M25 junction 28 improvement scheme

Supplementary consultation

4 November to 2 December 2019

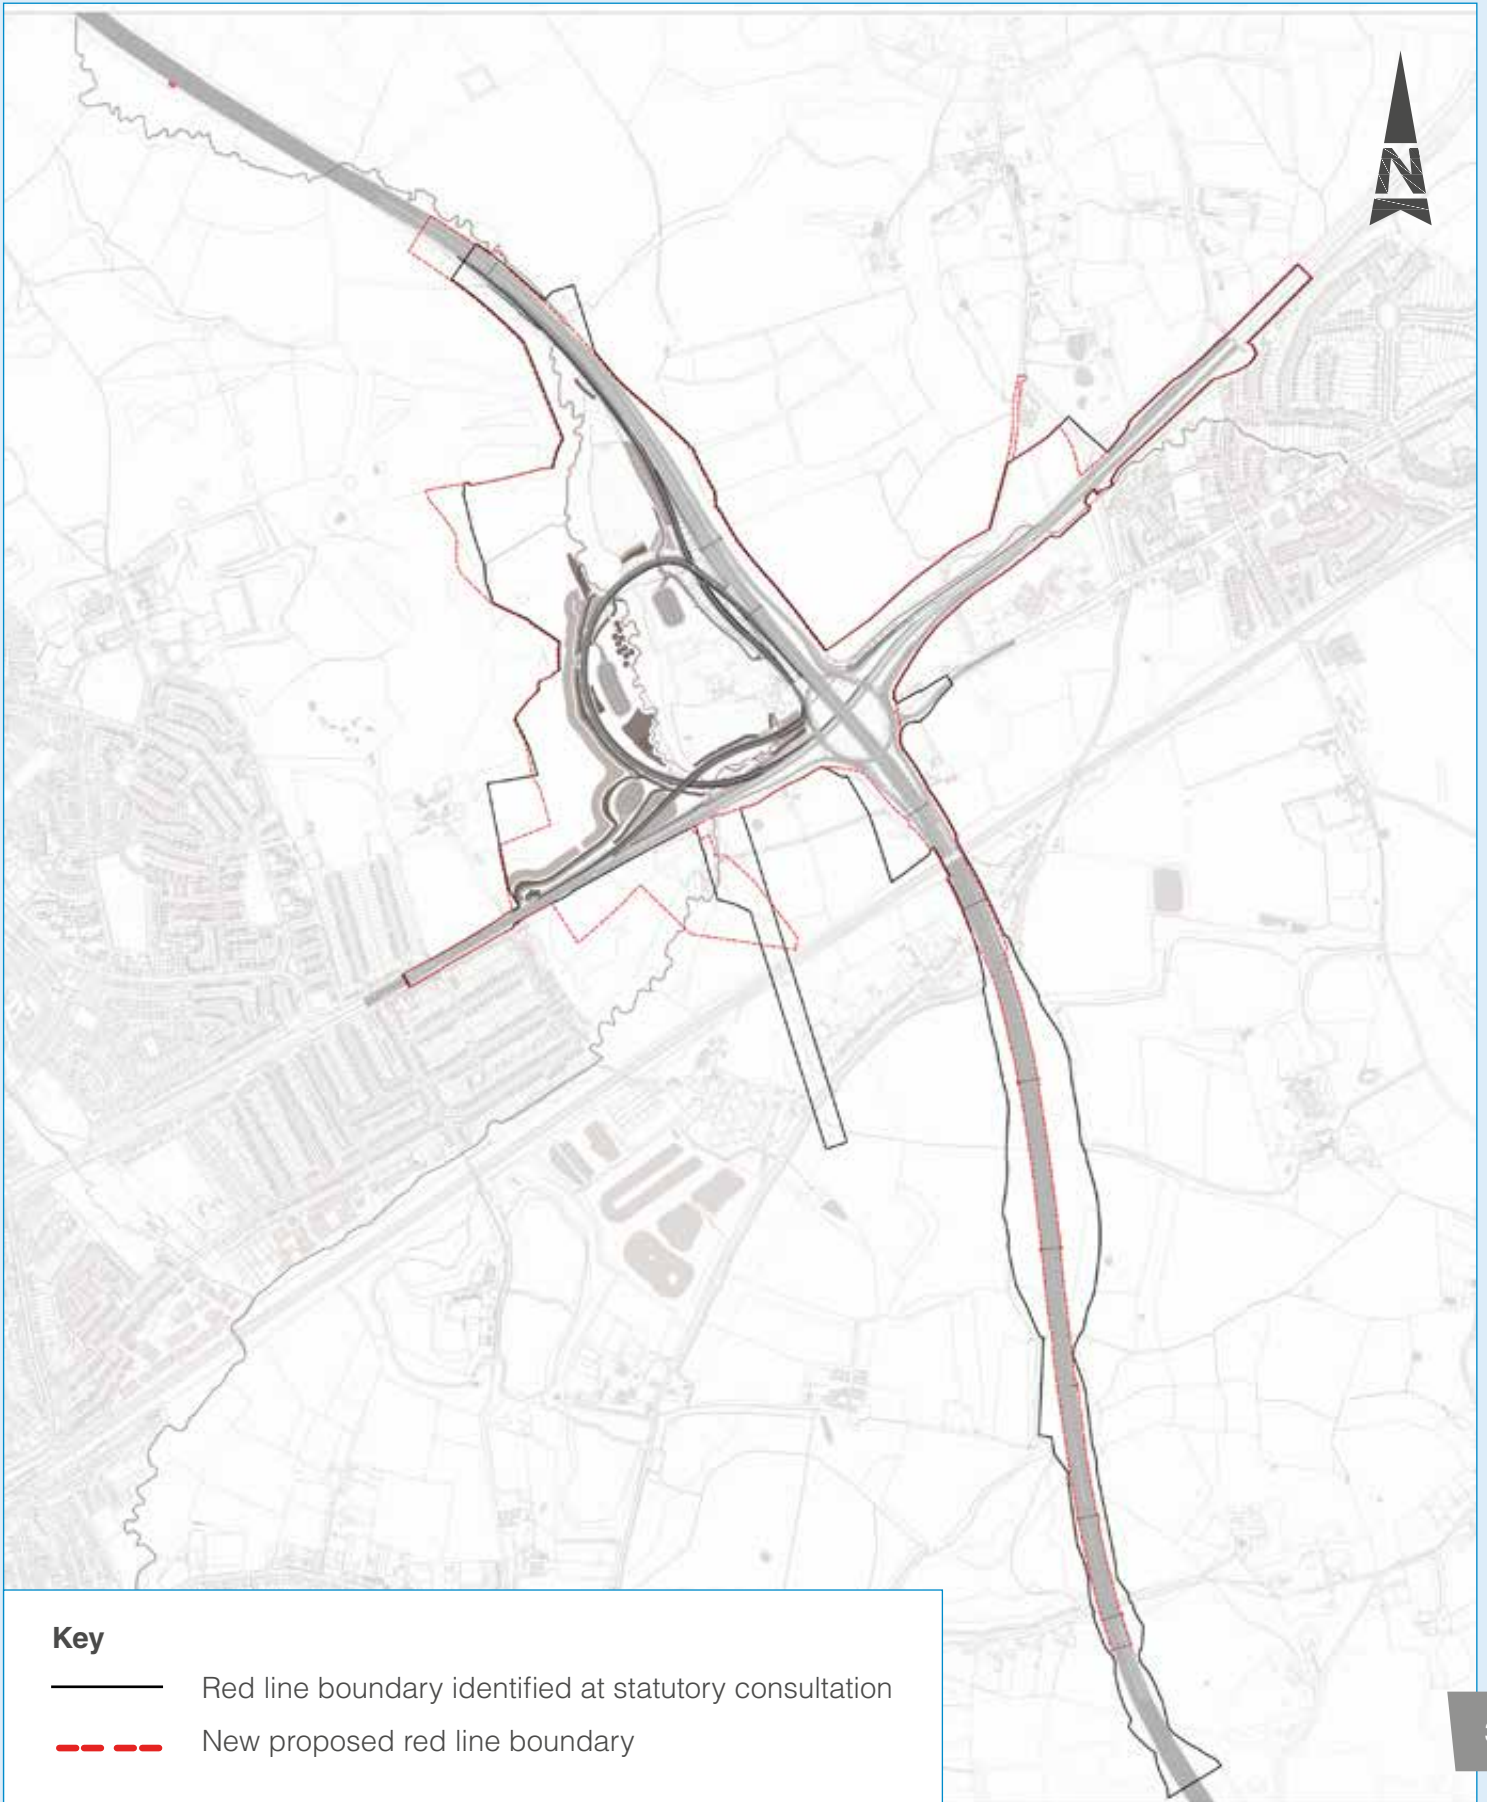
As a result, we are now proposing changes to the scheme and to the extent of the scheme red line boundary. The plan to the right shows the red line boundary identified at statutory consultation (refer to key) and the new proposed red line boundary.

Overview of key scheme changes

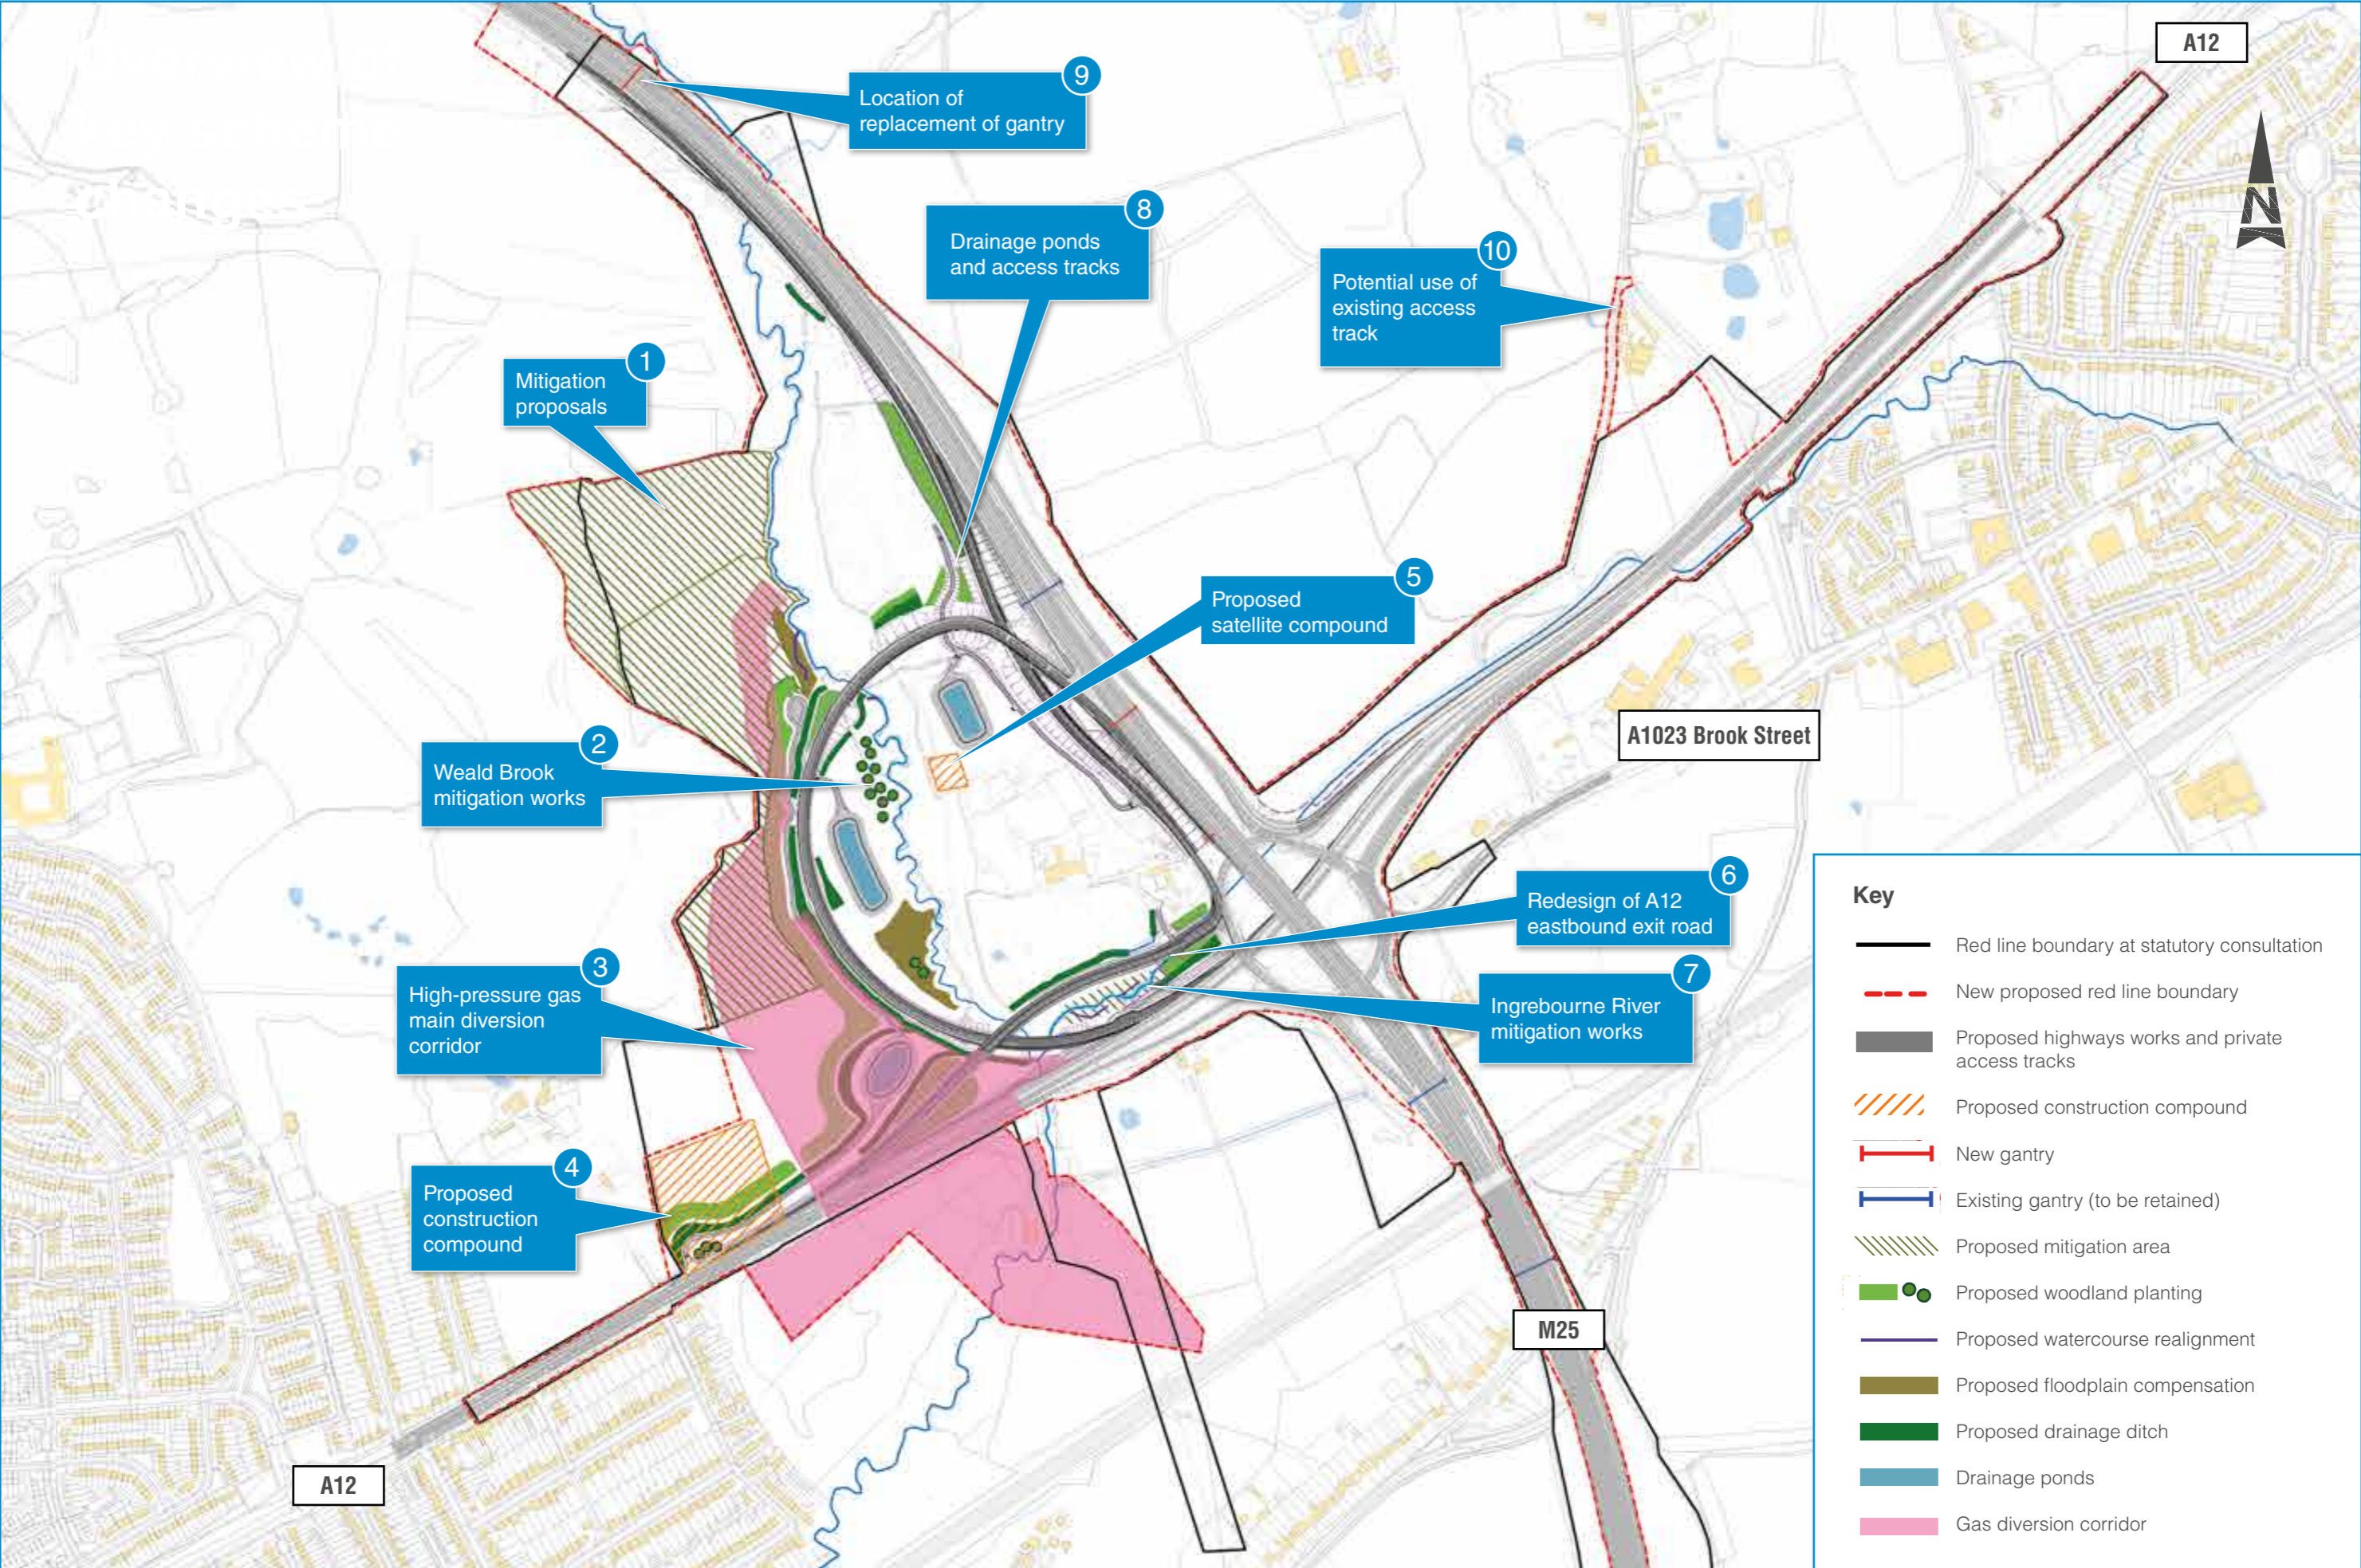
We have identified ten key changes to the proposals on which we would welcome your views:

1. Mitigation proposals
2. Weald Brook mitigation works
3. High-pressure gas main diversion
4. Proposed construction compound
5. Proposed satellite compound
6. Redesign of the A12 eastbound exit road
7. Ingrebourne River mitigation works
8. Drainage ponds and access tracks
9. Location of replacement of gantry
10. Potential use of existing access track

Diagram 1: Proposal at statutory consultation

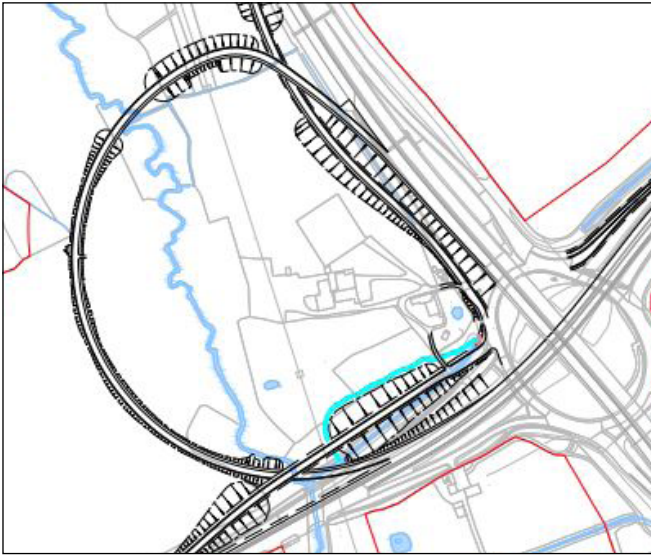
As explained at our last consultation, the proposed loop road would involve crossing the Weald Brook in two locations as indicated in [diagram 1](#). These crossings would involve the construction of bridges over and straightening of the watercourse. Further design refinement has identified that the bridge pier of Duck Wood bridge and the loop road embankment would encroach onto the floodplain.

Working in consultation with the Environment Agency, we have been developing proposals to mitigate these impacts on the watercourse and floodplain. It is now proposed to alter the course of the Weald Brook within the loop road to a more natural form as shown in [diagram 2](#).

Diagram 6: Proposal at statutory consultation

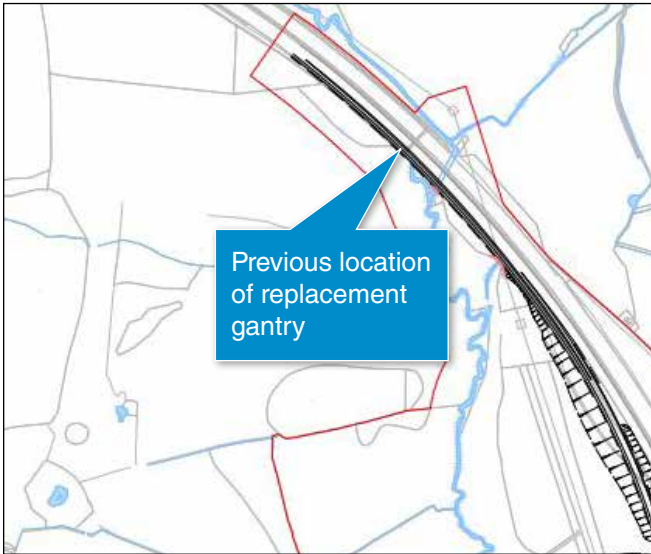
Our plans at statutory consultation indicated a working area on the southbound side of the M25 to enable us to modify an existing gantry (structure over the motorway that holds signage). Following discussions with landowners, we are now proposing a new gantry further northwards to avoid potential impacts that could arise to Maylands golf course from the previous gantry proposal. Therefore, we have extended the red line boundary northwards to accommodate the new proposed gantry. The plans on page 11 show the area at our last consultation ([diagram 6](#)) and our current proposal ([diagram 7](#)).

Indicative locations of veteran trees

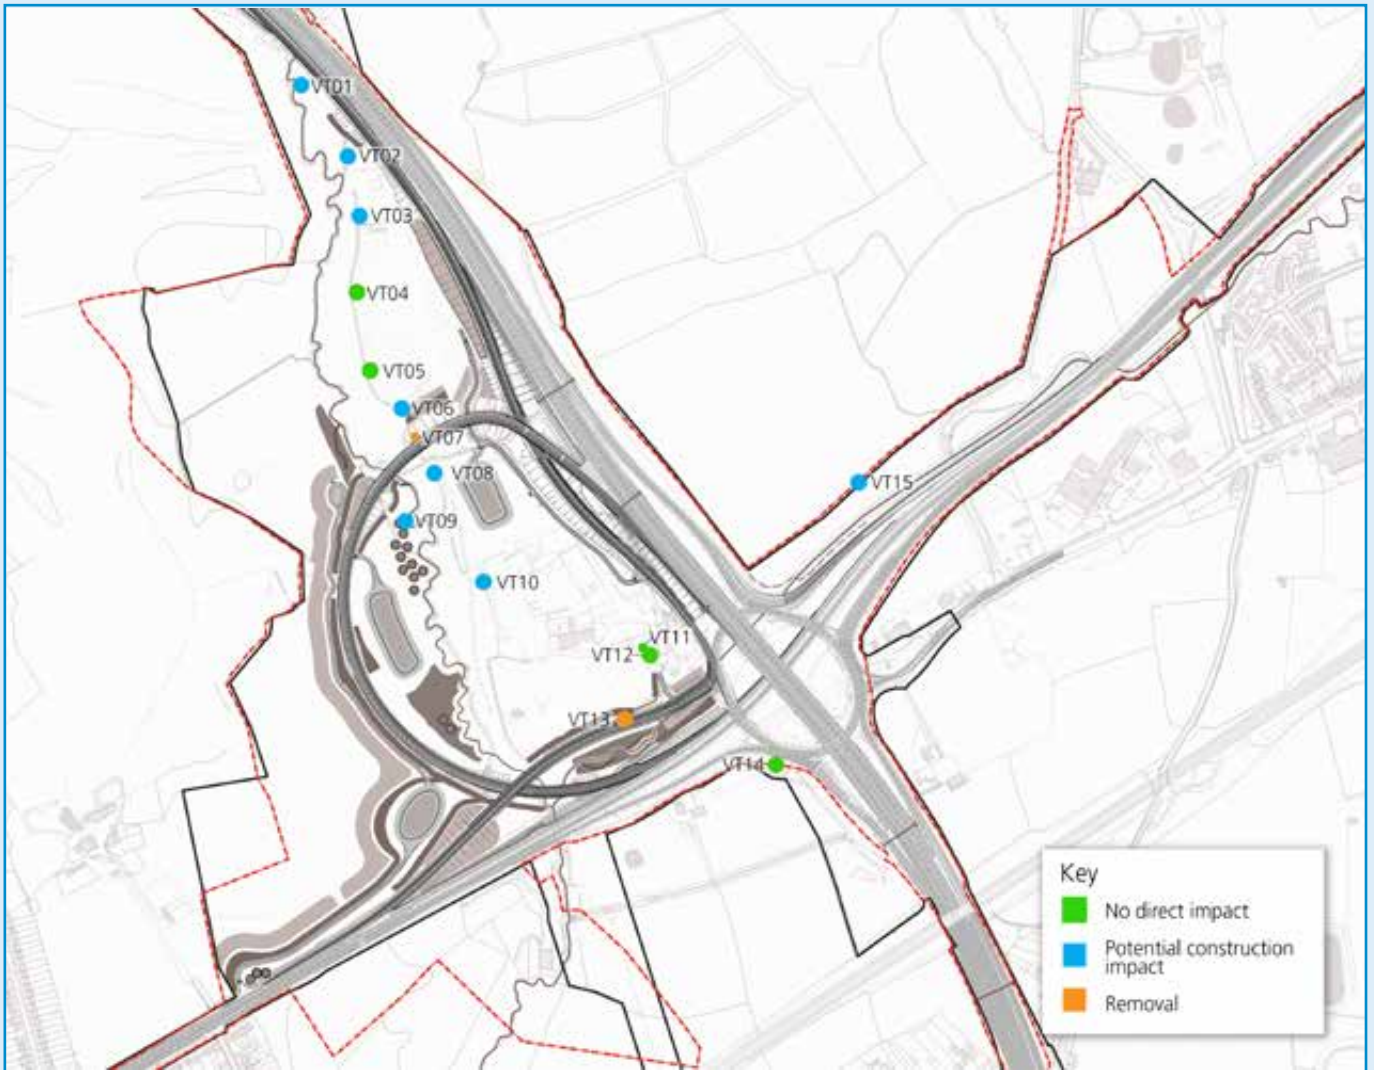
Prior to the above surveys, an initial desktop study was undertaken during the preparation of the PEIR, and this did not identify the presence of veteran trees. Since then, the arboricultural survey has been undertaken and this has identified the presence of 15 veteran trees within the scheme red line boundary, with three of these trees directly impacted by the scheme.

Through the ongoing design process, efforts have been made to avoid where possible the removal of veteran trees. Design changes were possible to avoid the removal of one veteran tree. Further design and construction alterations to avoid all veteran trees are not feasible, mainly due to highways design and road safety requirements.

- the removal of two veteran trees
- protective measures to eight of the veteran trees during construction works (these will be outlined in the OCEMP)
